PAHOKEE RESTORATION
CONTINUING AUTHORITIES PROGRAM
SECTION 1135 PROJECT
FINAL INTEGRATED FEASIBILITY STUDY AND ENVIRONMENTAL
ASSESSMENT

**Attachment 4 – National Environmental Policy Act (NEPA) Public and
Agency Comments and USACE Responses**

Table 1 Summary of USACE responses to comments received during the agency and public review and comment period of the draft Finding of No Significant Impact (FONSI) and Integrated Feasibility Report/Environmental Assessment (IFR/EA) for the Pahokee Restoration Section 1135 Continuing Authorities Program (CAP) project in Pahokee, Palm Beach County, Florida

Figure 3. Profiles of the Recommended Plan's low and high profile islands.

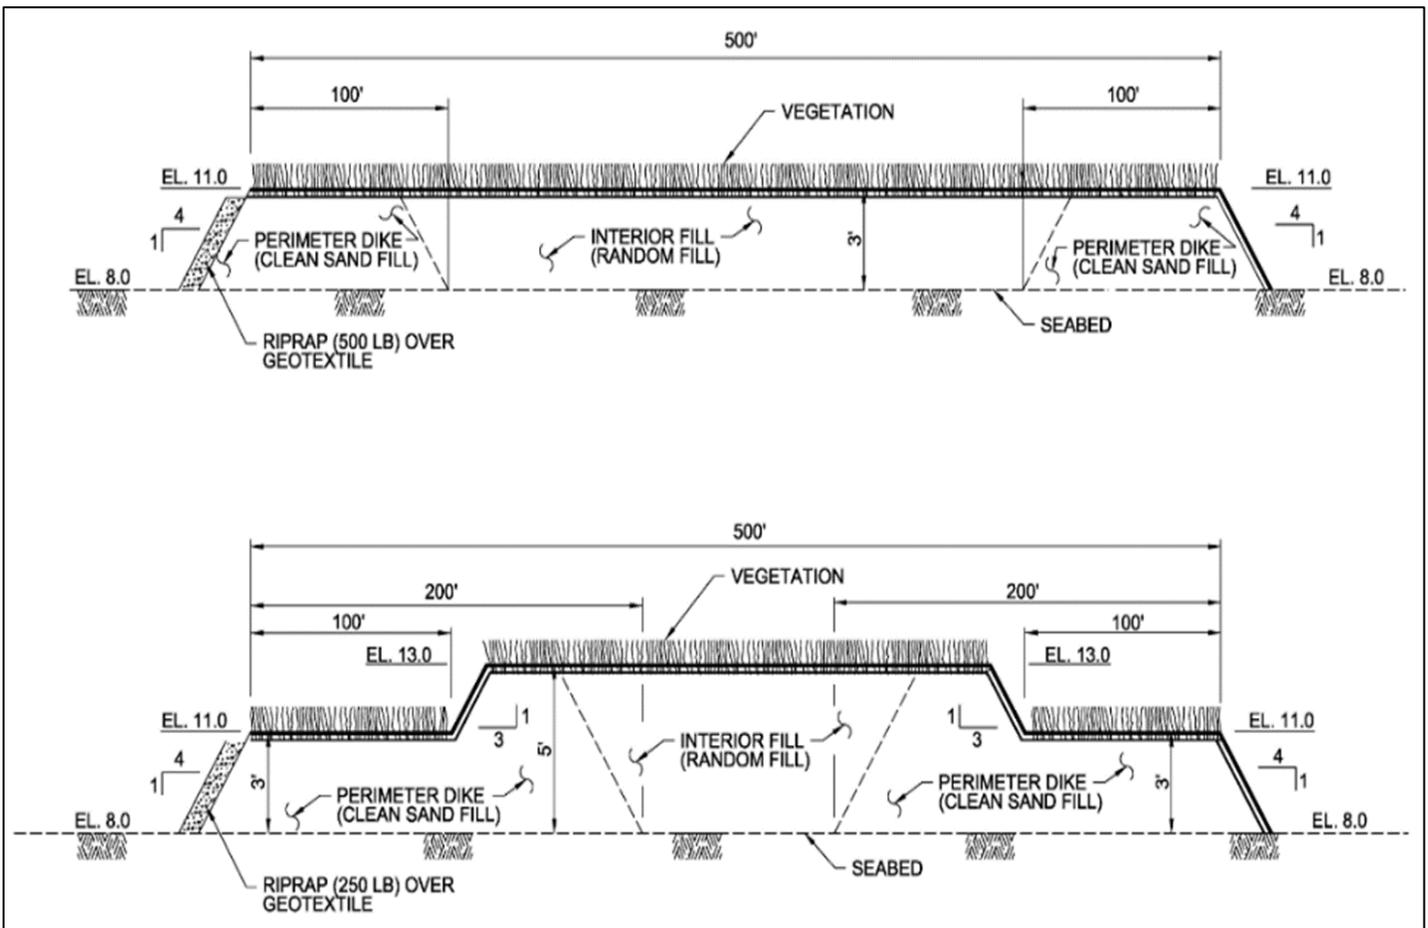
- On page 4-2 in Figure 4-1, the profile of the Tentatively Selected Plan (Alternative 5) does not include bedding stone between the riprap and the geotextile. USACE should specify the placement of bedding stone during the Design and Implementation Phase of the project.
- On page 5-12 in Table 5-5, the description of the cumulative effect for water quality should be revised to state “USACE and Palm Beach County are committed...” instead of “USACE and SFWMD are committed...”, because Palm Beach County is the non-federal sponsor.
- In Appendix A, Note 1 in Figure 5-3 states that the perimeter sand slope may need to be flatter than 1V:4H (e.g., 1V:5H, 1V:6H) depending on the behavior of the soft sediment/muck. FDEP appreciates USACE’s focus on the proposed slope of the perimeter berm, which will be a critical factor in the resiliency of the islands and their future maintenance cost.

4. Similarly, how will a 3:1 slope (or any engineered slope) connecting the lower elevation portion of the island to the upper elevation be established and maintained when regularly submersed in multiple feet of water (as depicted in Figure 4-1).

ISLAND (LOW PROFILE) + ISLAND (HIGH PROFILE)

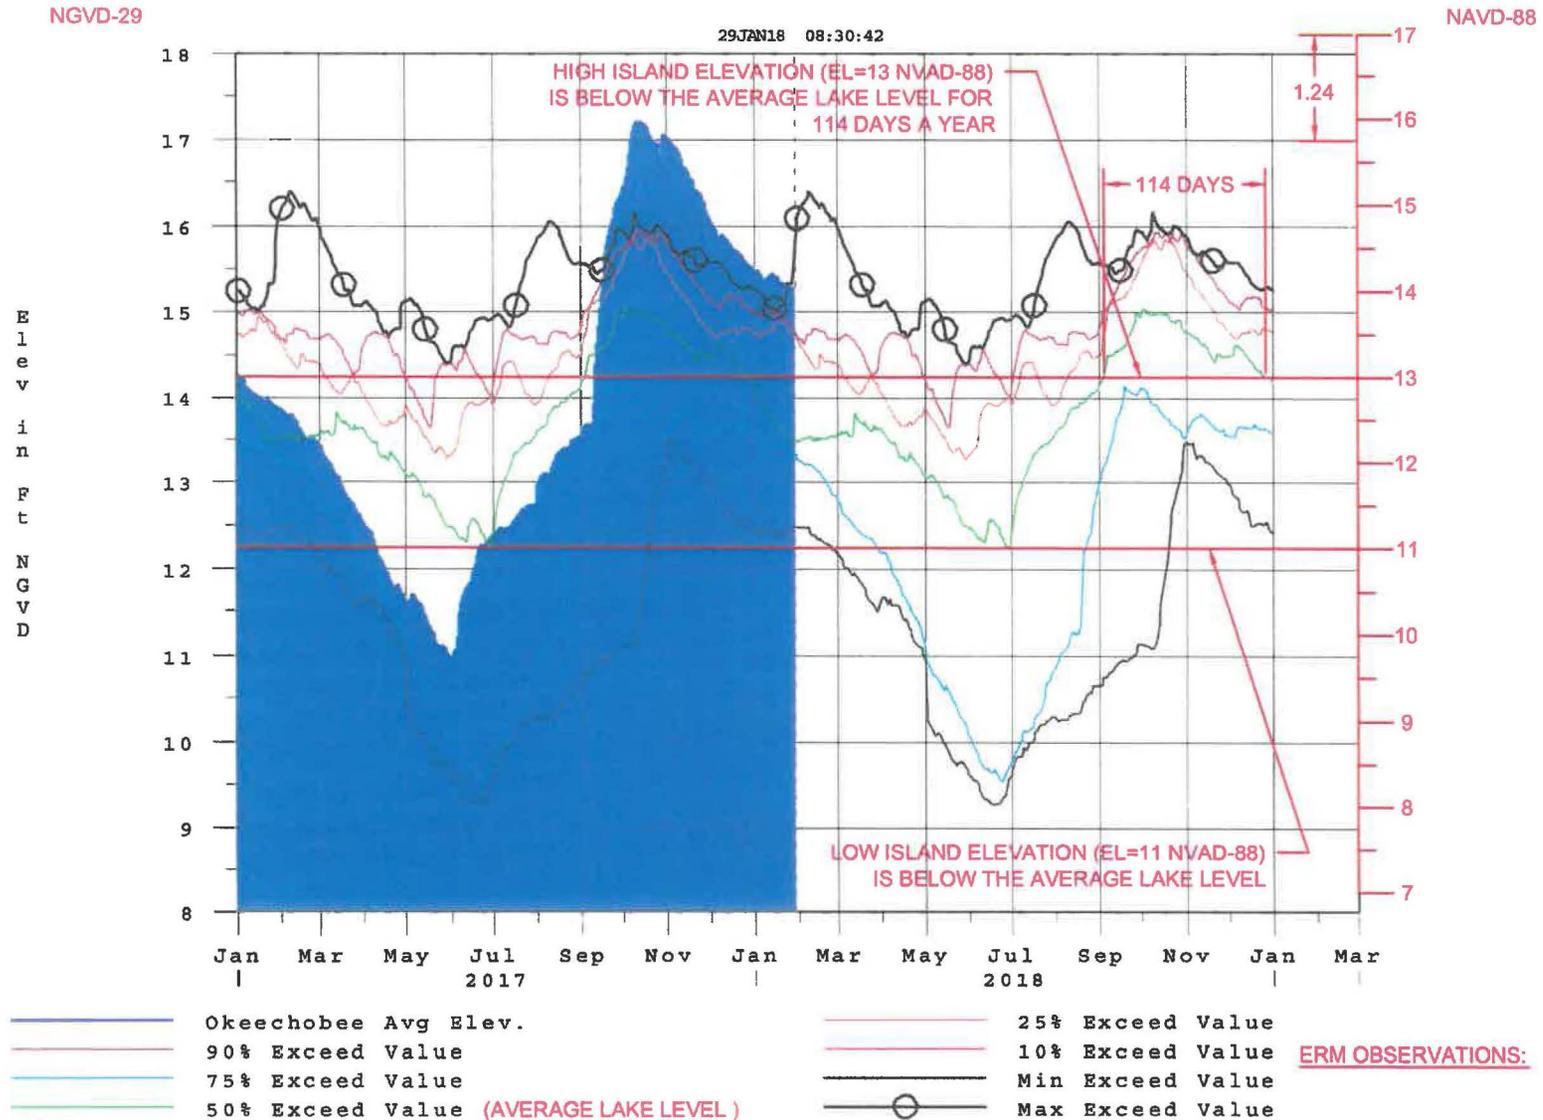
- Low Profile Island = 300 feet x 1500 feet
- High Profile Island = 100 feet x 1000 feet

To reduce project risk and increase project resiliency, Local Sponsor recommends:

1. Moving high profile island lakeward (west) of low profile island.
2. Adding emergent riprap slope protection to lake side of high profile island.
3. Raise average elevation of high profile to 14 ft-NAVD and raise average elevation of low profile island to 12 ft-NAVD.
4. Riprap all submerged 4H : 1V slopes or provide transitional slope component (min. 30H : 1V).
5. If suitable lake bottom material is found within a reasonable distance to justify cost to construct islands with dredged material, island to be constructed with dredged material only. Otherwise; islands to be constructed with upland material only.
